UNITED STATES PATENT AND TRADEMARK OFFICE

10/582,477

Office Action Summary	Application No. 10/582,477	Applicant(s) FITZ ET AL.	
	Examiner Kristina R. Fulton	Art Unit 3673

DETAILED ACTION

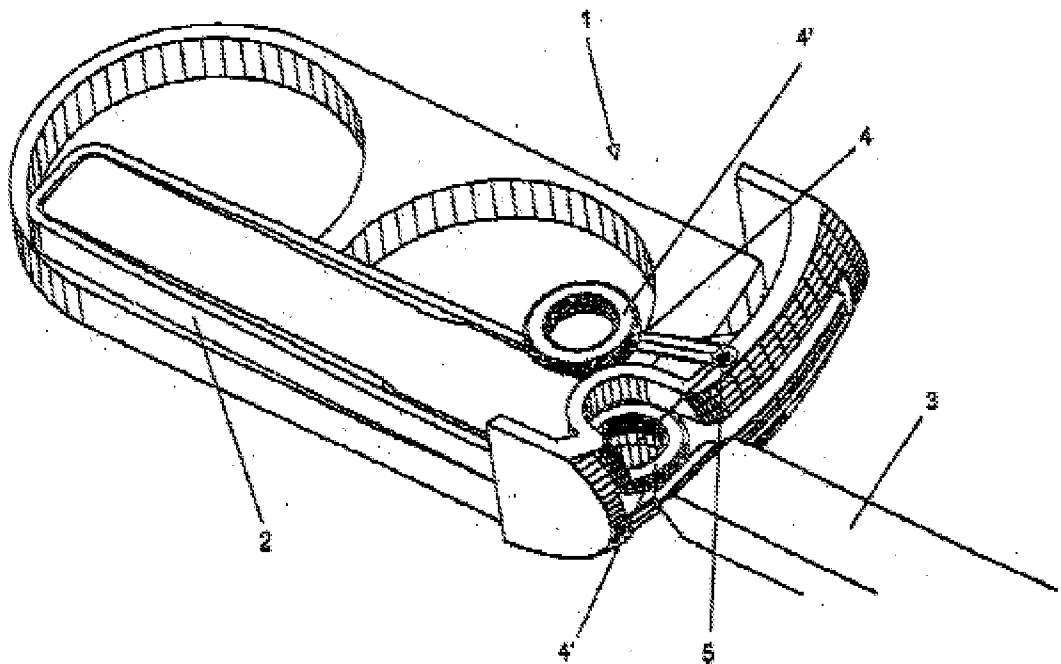
11. Regarding claims 10, 19 and 22, Donner shows an electronic key (1) having key housing (2) that has a suspension eyelet (4) in a region close to its periphery, the suspension eyelet having a deployed use and a stowed non-use position (see abstract), wherein the suspension eyelet is held by a guide arm (elongated arm portion of eyelet which pivots) which is mounted to the housing; the guide arm is movable such that the suspension eyelet is lowered into a receiving space in the key housing, in which it is inaccessible in its non-use position; and the suspension eyelet is movable out into the use position for the purpose of suspending the electronic key.

12. Regarding claim 11, the guide arm of the suspension eyelet is held on the key housing by means of a rotary bearing (5), such that it can pivot.

13. Regarding claims 12 and 23, the guide arm of the suspension eyelet is held on the key housing such that it can slide (figures 2 or 3). Please note that the eyelet can move in and out of the housing and therefor reads on the claim. The method of motion (pivot, slide, rotate, etc) is not considered critical and therefor not patentably distinct.

17. Regarding claim 21, said mechanical key has a suspension structure (overlapping the eyelet) by which the electronic key can be suspended when the suspension eyelet is in the stowed position. See the Donner device below.

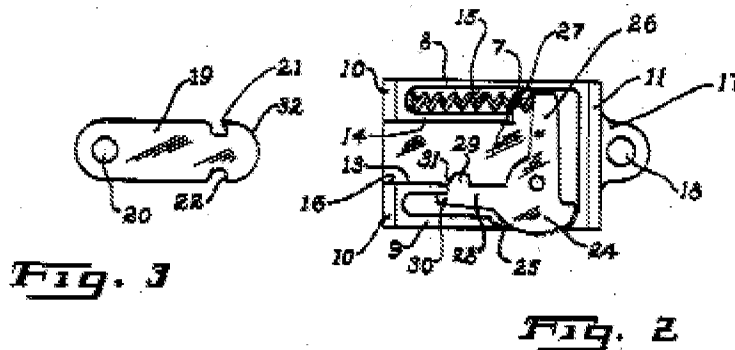
Donner shows applicant's inventive concept including a suspension eyelet supported against a holding zone of the mechanical key and a bearing point of the key housing but fails to include a spring. Nolan shows that it is well known in the key art to include a spring for projecting an object from the housing. It would have been obvious to one of

ordinary skill in the art to include a spring in the Donner device in order to assure the proper extraction of the eyelet. Adding a spring to Donner is a reasonable and obvious modification and would have yielded predictable results. See the Nolan device below.
